# UNITED STATES PATENT AND TRADEMARK OFFICE

APPLICATION NO.	FILING DATE	FIRST NAMED INVENTOR	ATTORNEY DOCKET NO.	CONFIRMATION NO.
09/901,079	07/10/2001	Dong-Hoon Lee	8733.464.00	7082
30827	7590	01/11/2005	EXAMINER	
MCKENNA LONG & ALDRIDGE LLP 1900 K STREET, NW WASHINGTON, DC 20006			RUDE, TIMOTHY L	
			ART UNIT	PAPER NUMBER
			2883

## Office Action Summary

## DETAILED ACTION

**FIG. 3(a)**

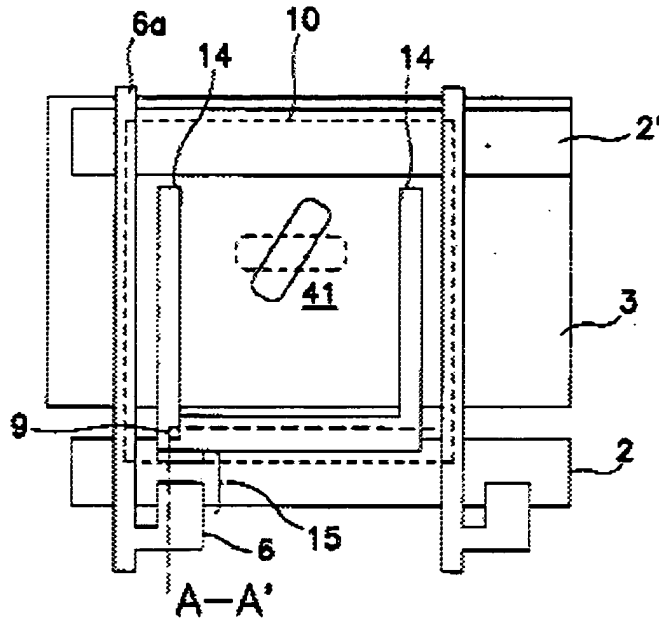
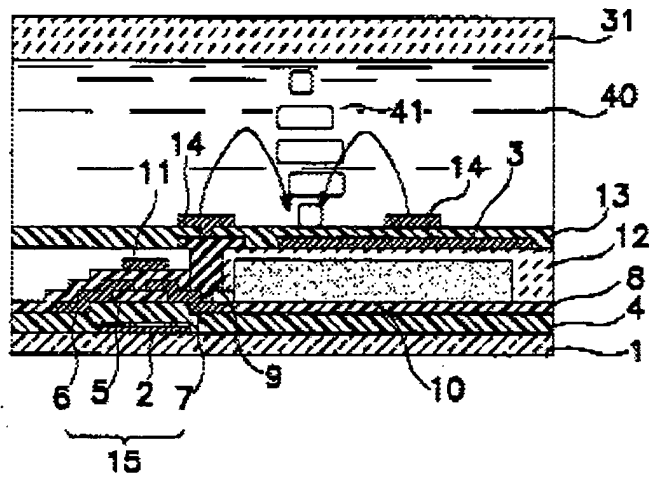
Sakamoto teaches 1), (entire patent, especially embodiment 2) in Drawings 3(a) and 3(b), the use of a common electrode, 3 (col. 8, line 23 through col. 10, line 7), on a protective overcoat layer, 12 (Applicant's the first passivation layer); an interlayer film, 13 (Applicant's second passivation layer) on the first passivation layer; and a pixel electrode, 14, on the second passivation layer to allow for manufacture of a color display that prevents color unevenness for better display performance (col. 4, lines 1-2).

Sakamoto, as combined above, discloses a device wherein the first passivation layer includes a contact hole for connecting the pixel electrode (per Figure 3(b)).

As to claims 13 and 14, Sakamoto discloses a device wherein the second passivation layer includes a drain contact hole to electrically connect the pixel electrode to the drain (per Figure 3(B)).
